February 12, 2020

Subject: Response to DMS comments on the Year 5 Monitoring Report Review for the Upper Silver Creek Stream and Wetland Restoration Project; Catawba River Basin - CU# 03050101; Burke County, North Carolina; NCEEP Project # 94645; Contract No. 003270

Upper Silver Creek Restoration Project Year 5 Monitoring Report

**Burke County, North Carolina
NCDMS Project ID Number – 94645**

Figure 2 - Overview
Current Conditions Plan View
Monitoring Year 5
Upper Silver Creek Site

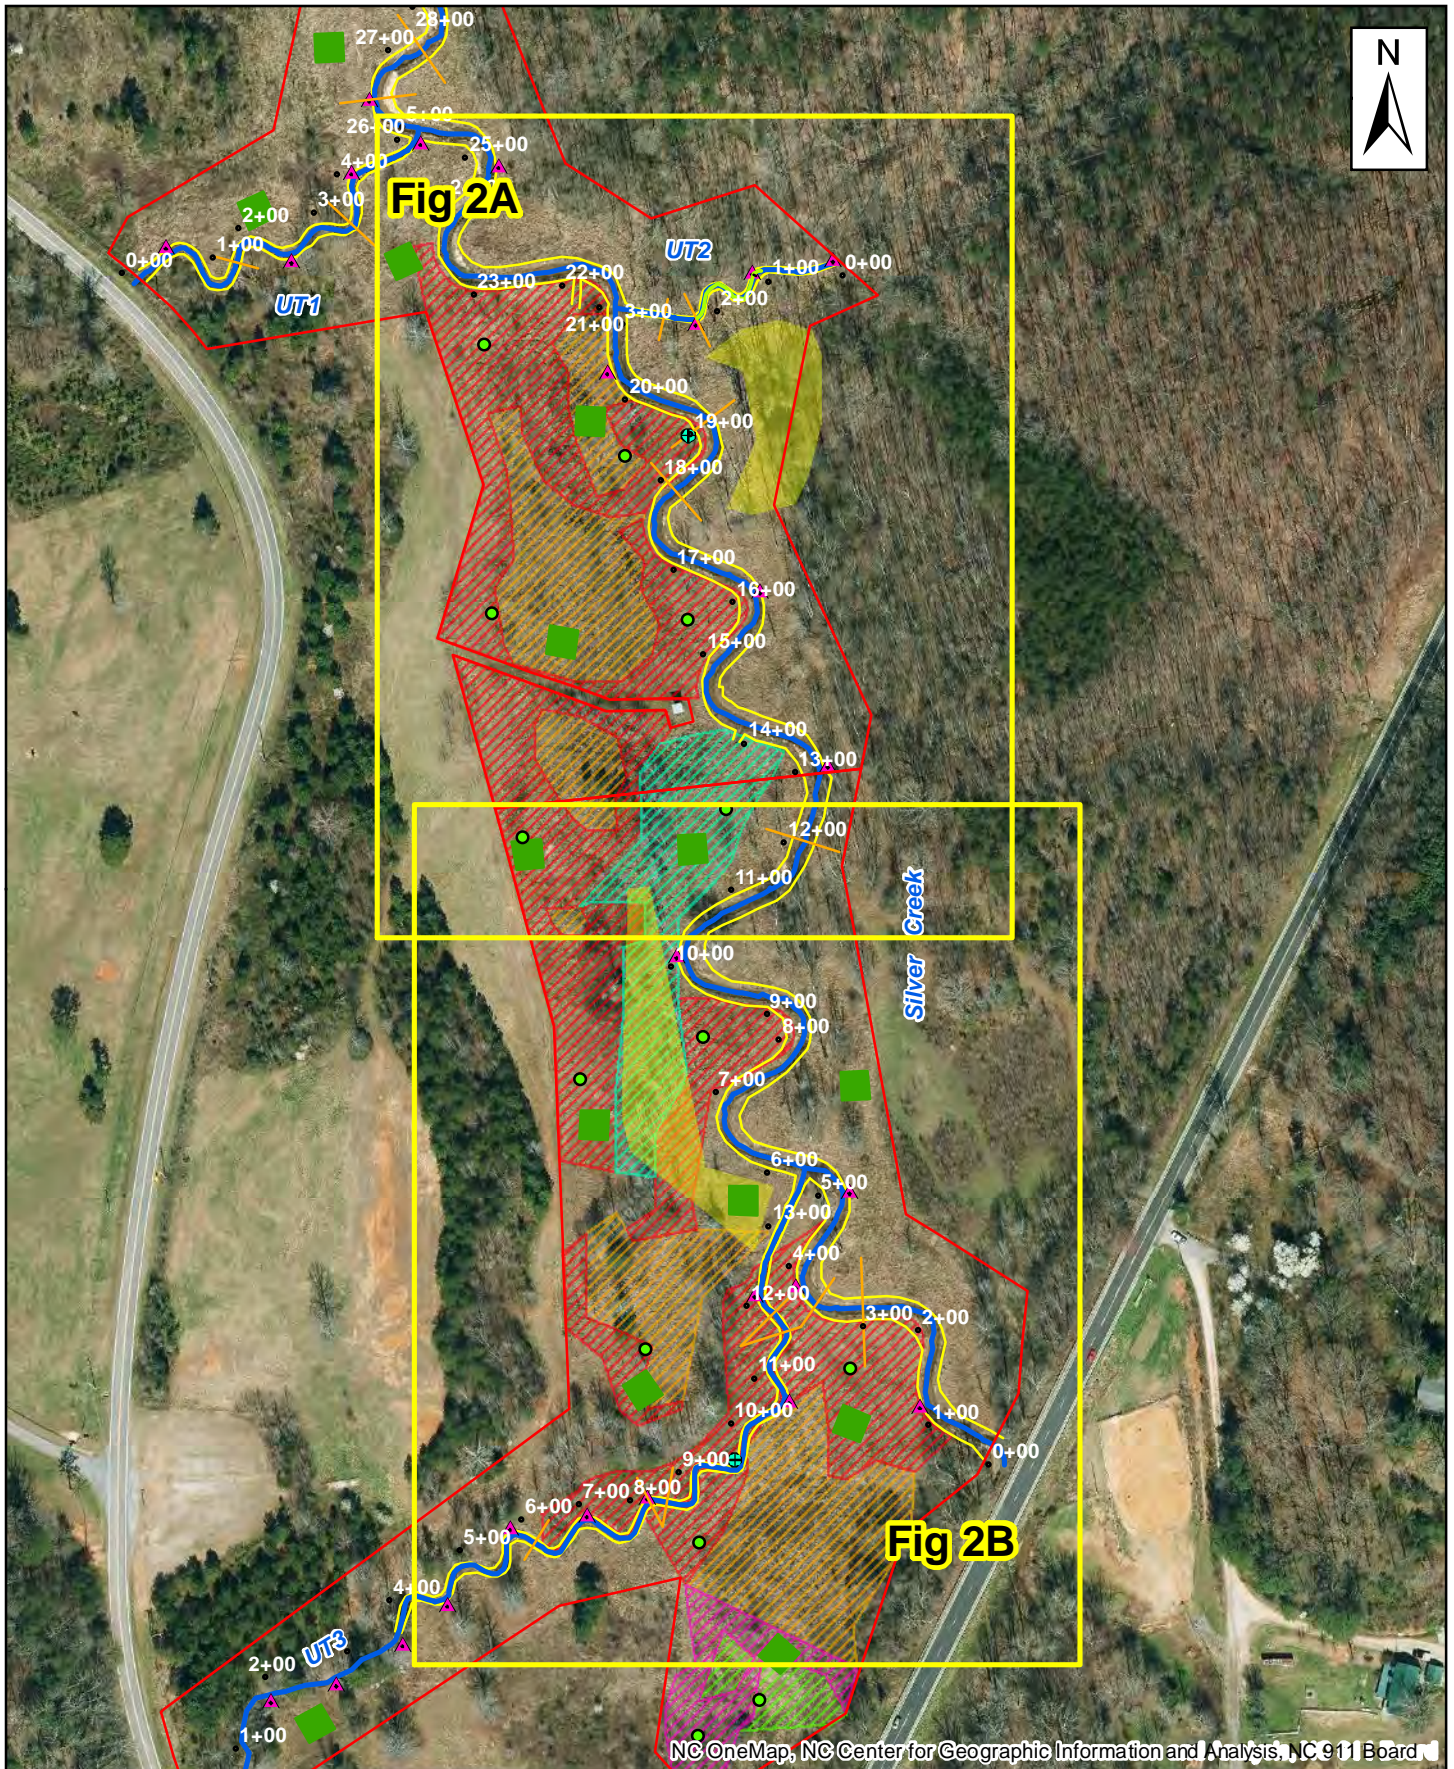
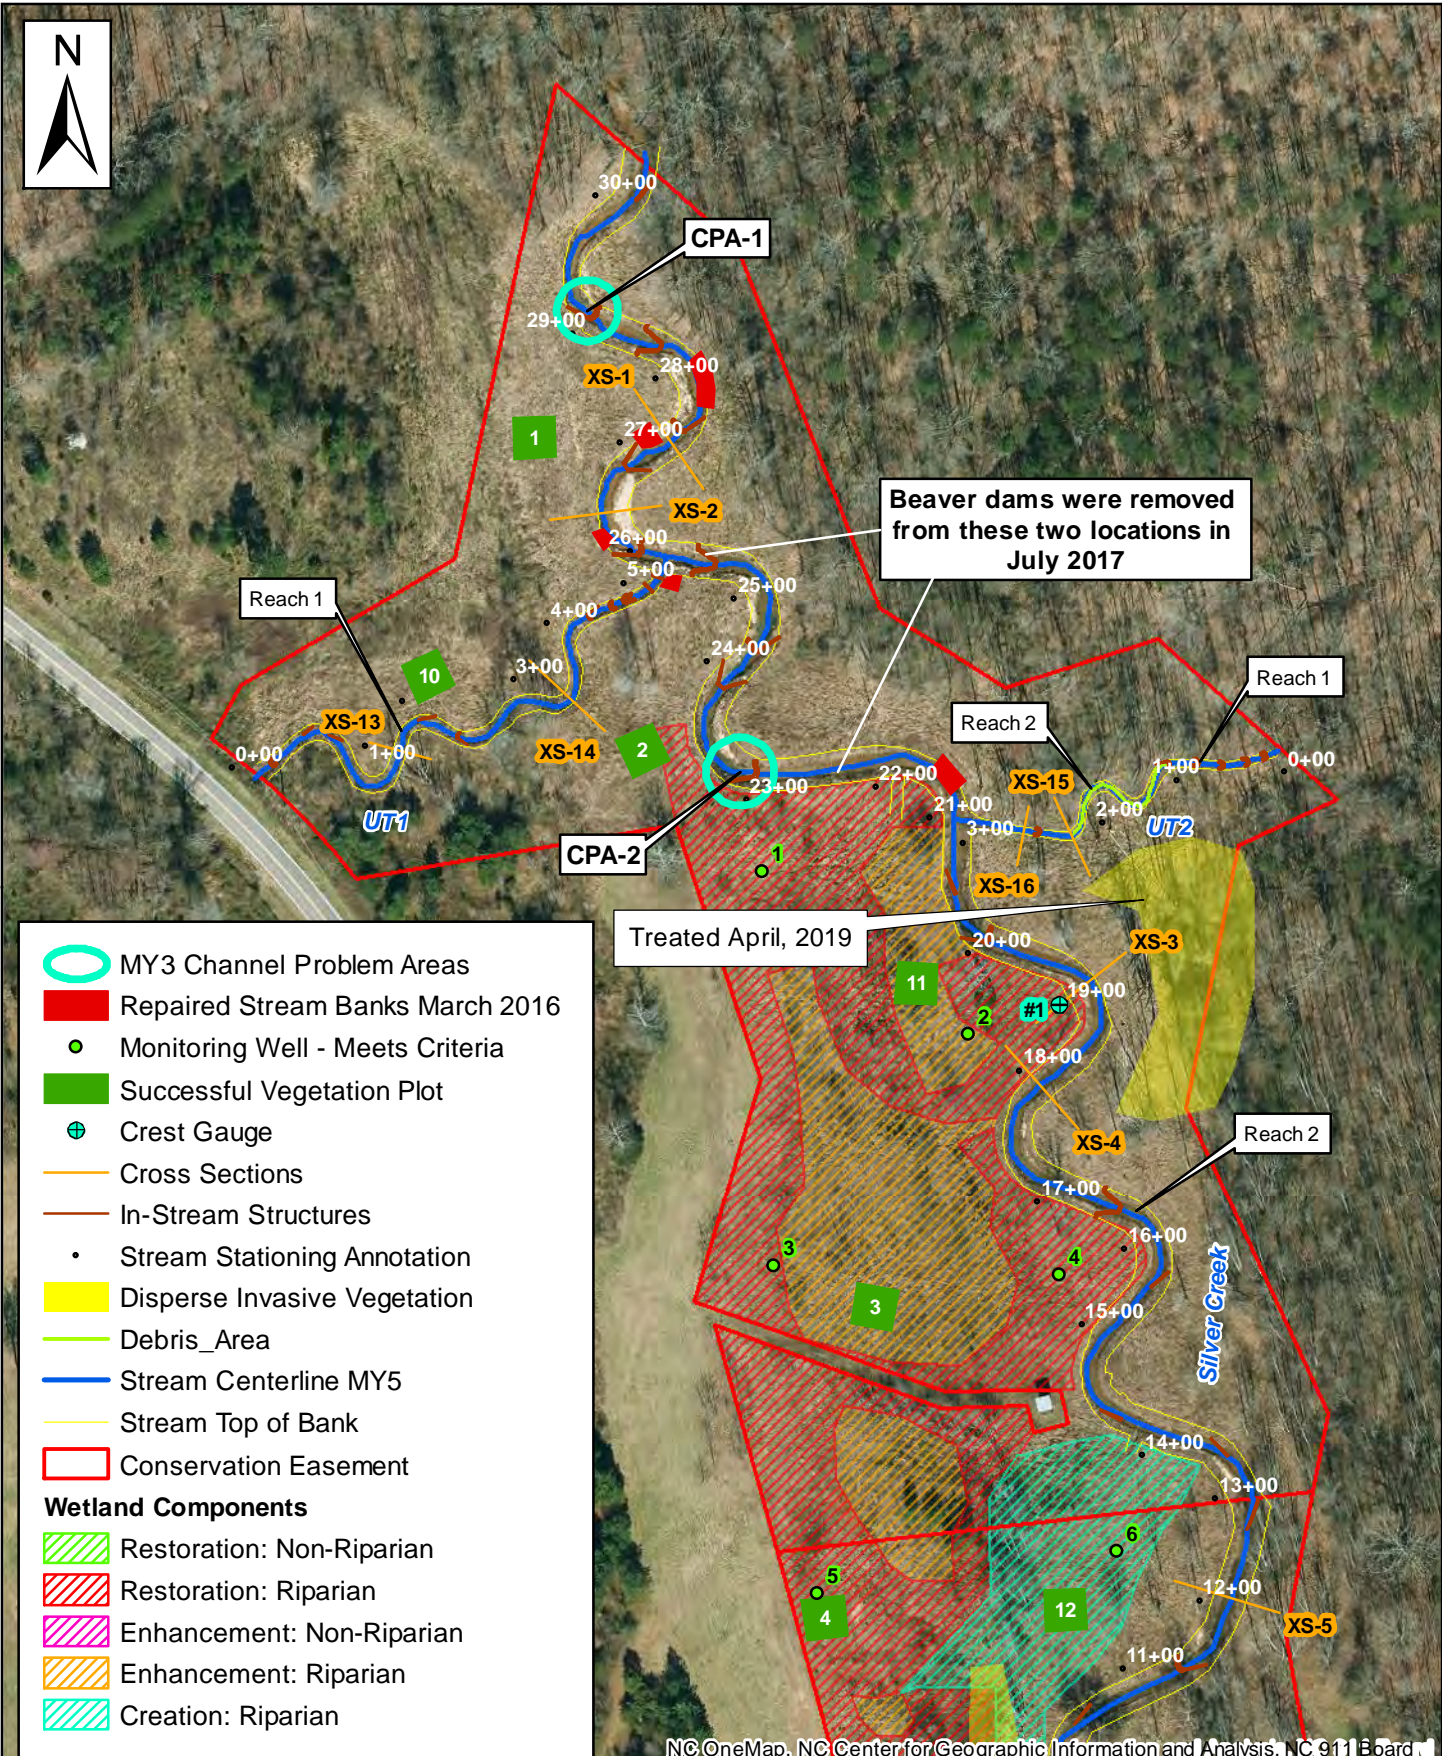
- Page 2: Invasive discussion is unclear where area is within the site and is also not shown on CCPV. Please update description and include on CCPV.
Location of invasive plant growth has been updated in the narrative and the CCPV map has been modified as well.

- In the legend, please add a year to the “Repaired Stream Bank” entry to clarify when this work was completed.

- Please add the locations of the debris/obstruction removal and sediment removal that occurred in 2019.

- Please add stationing to the CCPV and Figure 3.

- Include invasive polygons.

Stream Bank was repaired in March 2016 and this date has been added.

Location of debris/obstruction removal has been added.

Stationing has been added.

Invasive locations discussed in the text have been added.
